RECEIVED
OFFICE OF ZONING**MEMORANDUM**

FROM: Jennifer Steingasser, Deputy Director Development Review & Historical Preservation

SUBJECT: BZA Case 18096 - Request for a special exception for 2513-2517 Alabama Avenue SE

Figure 1

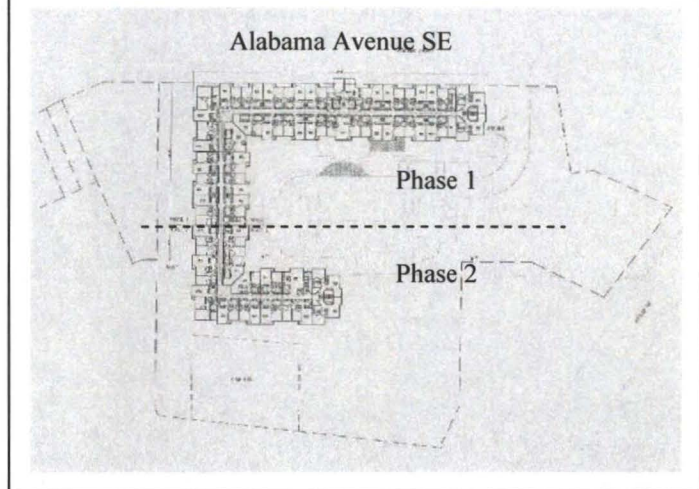
This is the first of two development stages. Sometime after this application is approved, the applicant plans to petition the District Department of Transportation (DDOT) to close the bordering alley to the south. A three-story addition would then be constructed, continuing the apartment building across the former alleyway onto another tract of land under common ownership. The final L-shaped structure would wrap around the west end of the central parking area (refer to Figure 1 to the right).
